**ADDENDUM NO. 2**

Re: **GS# 101-328**  
Dormitory Renovations  
Alcorn State University  
Lorman, Mississippi

**ADDENDUM NO. TWO (2)**

GS# 101-328  
Dormitory Renovations Alcorn State University  
Lorman, Mississippi  
ERG P.N. 23.123

Third Floor Renovation Plan - Plumbing "Supply" (Robinson Hall)

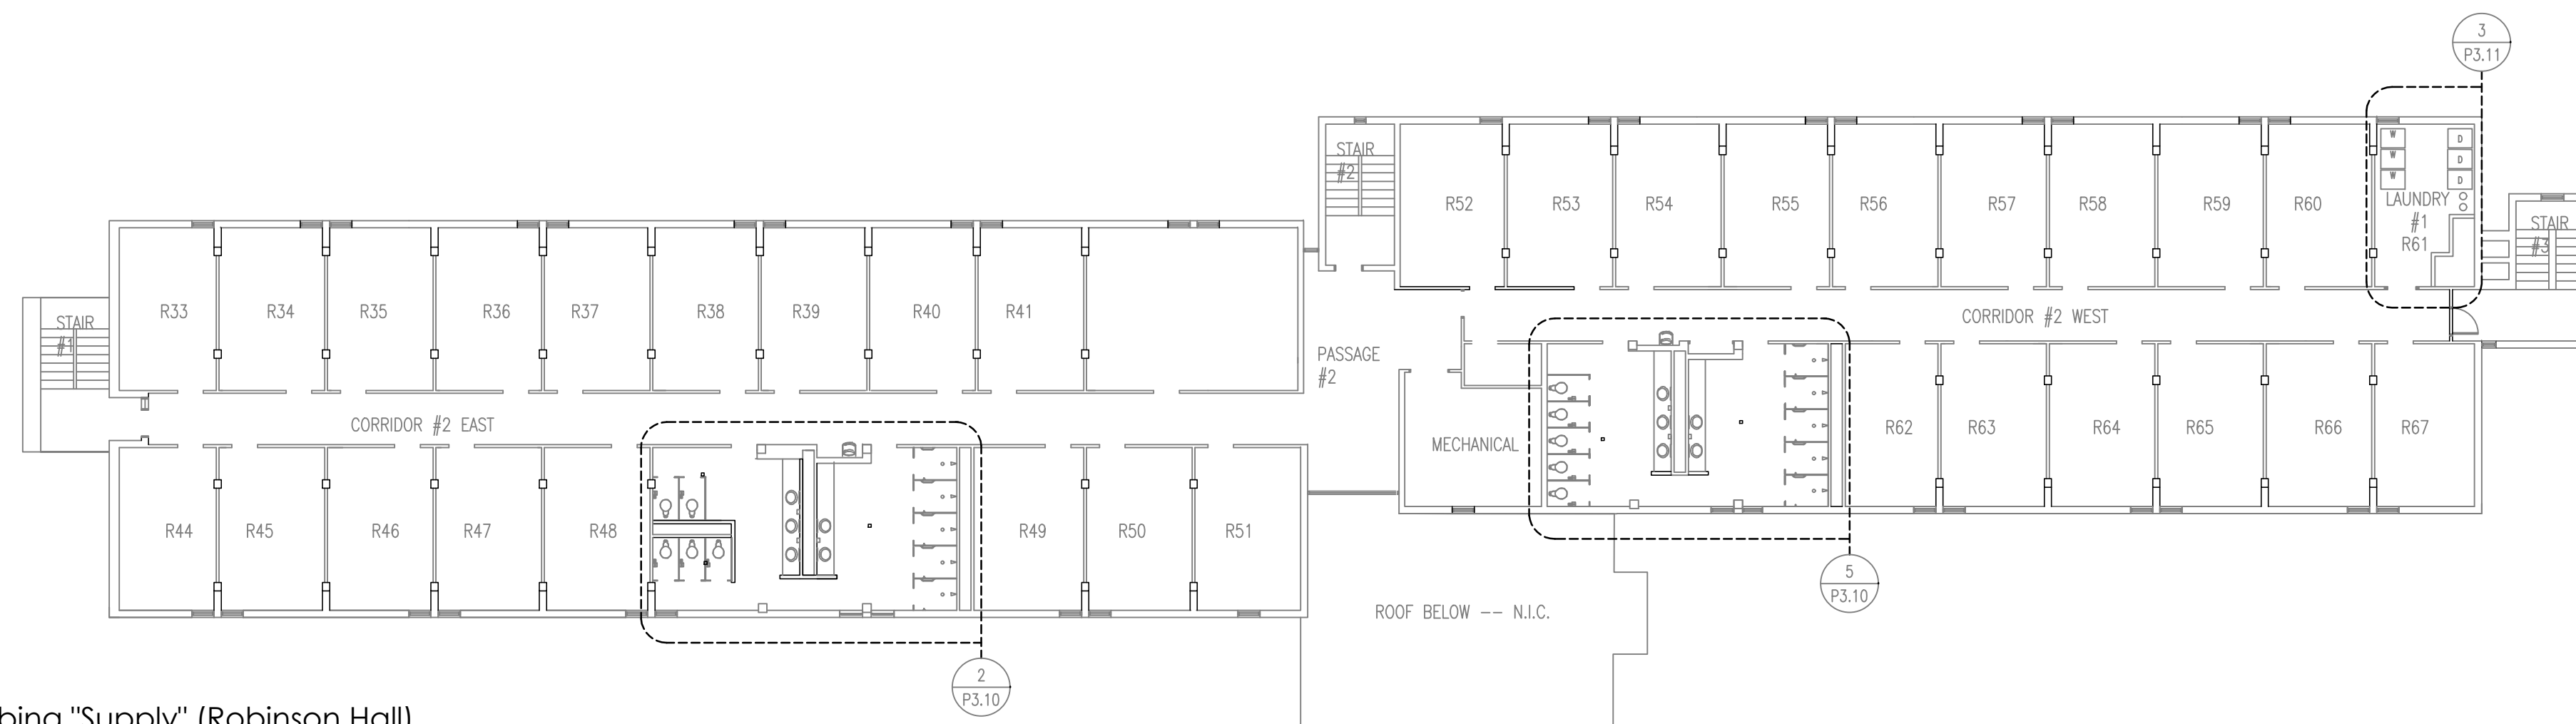
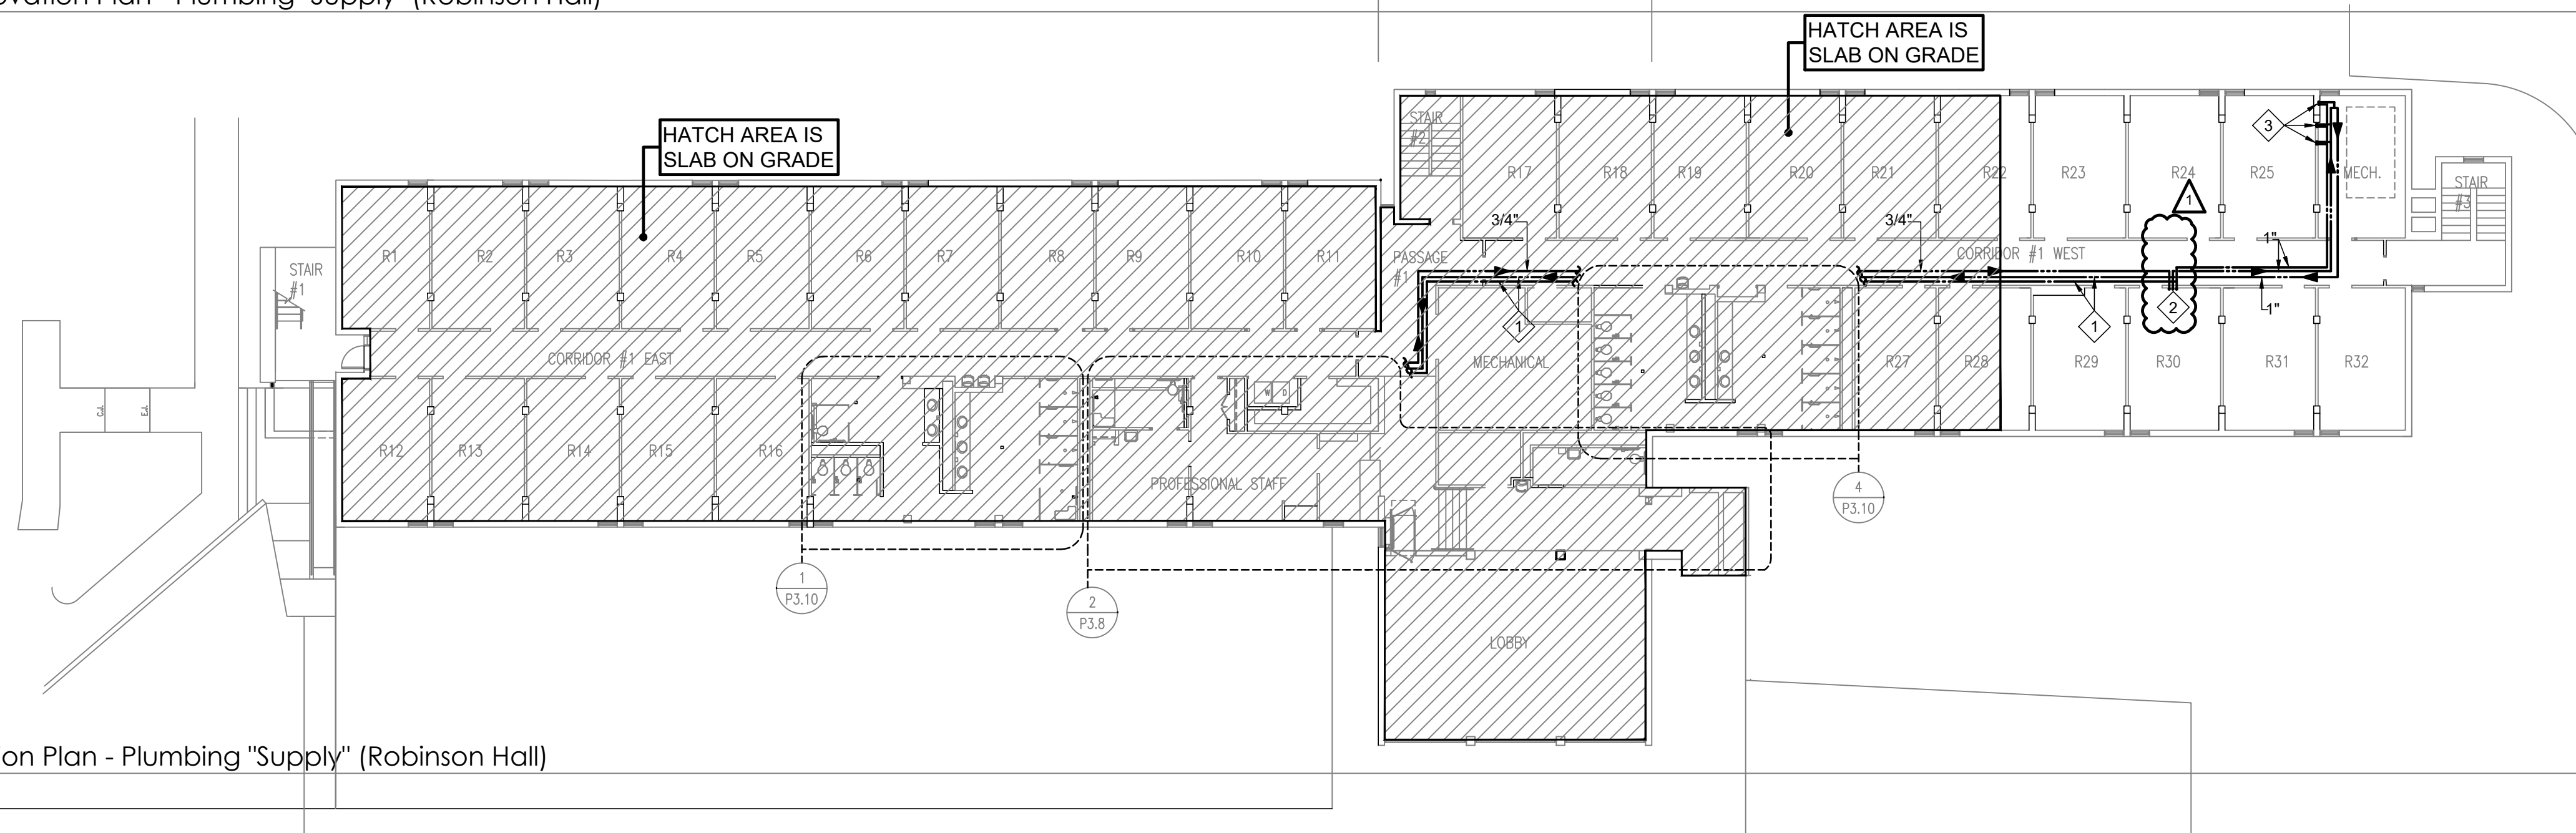
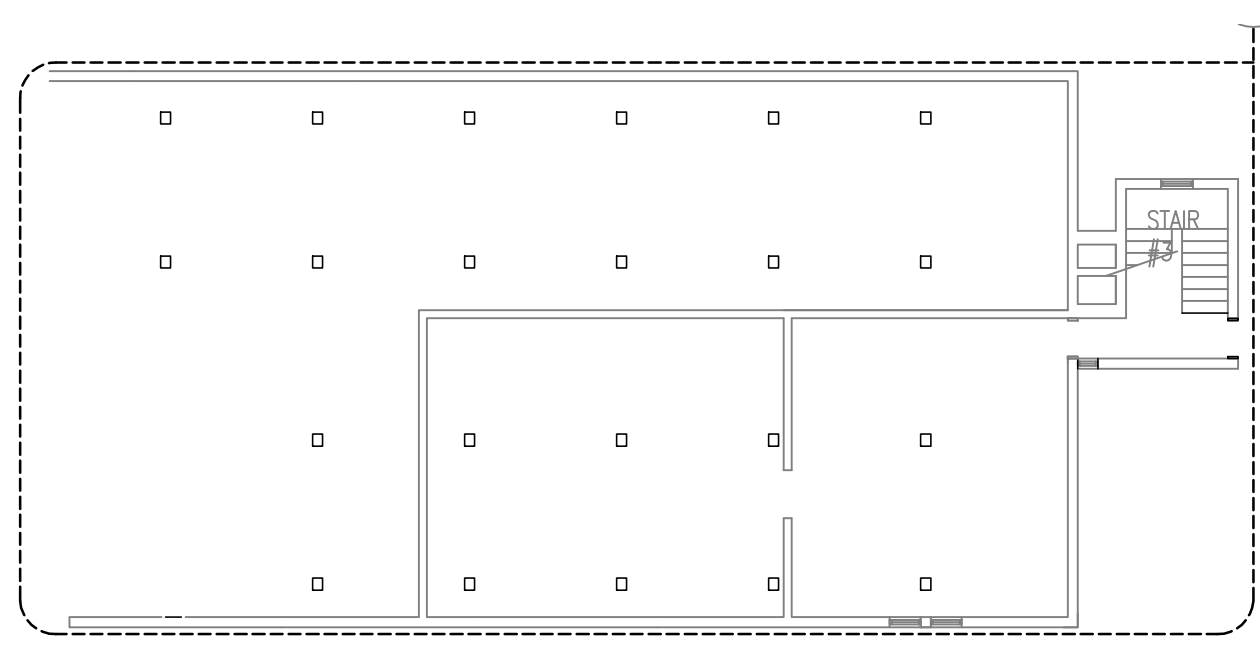
- A. Sheet P0.1: Revised Plumbing General Notes.
- B. Sheet P2.2: Relocated cold, hot, and hot water recirc mains from Dorm R24 to R30.
- C. Sheet P3.0: Revised piping at L-2 located in Prof. Staff Bed.
- D. Sheet P3.1: Revised filtration system and added Make/Model.
- E. Sheet P3.7: Revised piping at L-2 located in Professional Staff.
- F. Sheet P3.8: Revised filtration system and added Make/Model. Revised routing of cold, hot, and hot water recirc piping up to first floor.

1. NEW 3" CW & 2" HW, RUN ABOVE CEILING.
2. NEW 3" CW, 2" HW, AND 3/4" HW RECIRC FROM BASEMENT. RISE ON DORM SIDE OF WALL AND RUN ABOVE CORRIDOR CEILING.
3. 3/4" CW & HW UP.
